Access Compliance Report

Public Rights-of-Way

(Curb Ramps)

Intersection ID: 2762	Main Street: BRADWELL_DR	Cross Street: MCTAGGART_LN	Location: SW
ADA ID: 8E517281D440	Ramp Type: Perpendicular Diagonal	Initial Pass/Fail: Fail	Overall Compliance: No
Severity Score: 21.25			
Codes/Mitigation Info/Possible Solution		Field Measurements/Component Compliance

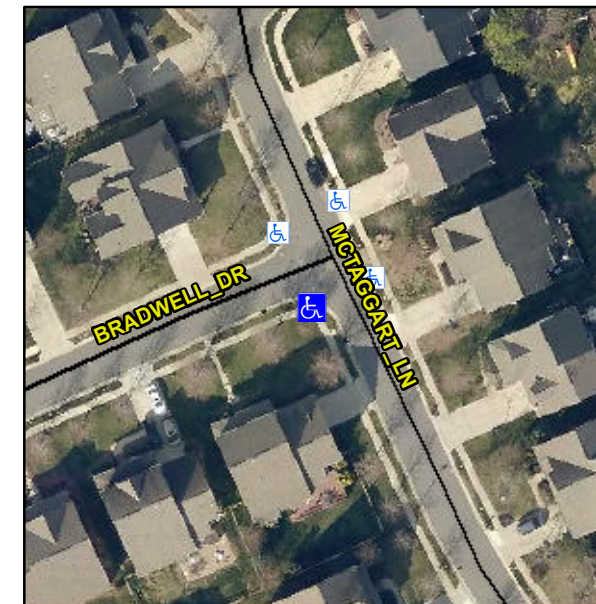
Not Found, R304.5.1, R304.2.2

Compliance	Description	Data	Compliance	Description	Data
N/A	Ramp Length (in)	48.0	No	Ramp Slope (%)	10.4
No	Ramp Width (in)	40.0	Yes	Ramp XSlope (%)	0.6
N/A	Flare Type LT	N/A	N/A	Flare Type RT	N/A
N/A	Flare Slope LT (%)	N/A	N/A	Flare Slope RT (%)	N/A
N/A	Flare Traversable LT?	N/A	N/A	Flare Traversable RT?	N/A
N/A	Landing Length (in)	N/A	N/A	DWS Provided?	N/A
N/A	Landing Width (in)	N/A	N/A	DWS Contrast?	N/A
N/A	Landing Slope (%)	N/A	N/A	DWS Length (in)	N/A
N/A	Landing X Slope (%)	N/A	N/A	DWS Full Width?	N/A
N/A	Landing Curb? (Y/N)	N/A	N/A	DWS Offset (in)	N/A
N/A	Shared Landing?	N/A			
N/A	Gutter Ponding?	N/A	N/A	Gutter Slope (%)	N/A
N/A	Gutter Lip Ht (in)	N/A	N/A	Gutter X Slope (%)	N/A
N/A	Painted X Walk1?	No	N/A	Painted X Walk2?	No
	X Walk 1 Direction	To E		X Walk 2 Direction	To N
N/A	X Walk 1 Width (in)	N/A	N/A	X Walk 2 Width (in)	N/A
	X Walk 1 Slope (%)	3.0		X Walk 2 Slope (%)	2.9
	X Walk 1 X Slope (%)	1.1		X Walk 2 X Slope (%)	0.6

Remove & Replace Curb Ramp With Two New Directional Ramps or Equivalent.
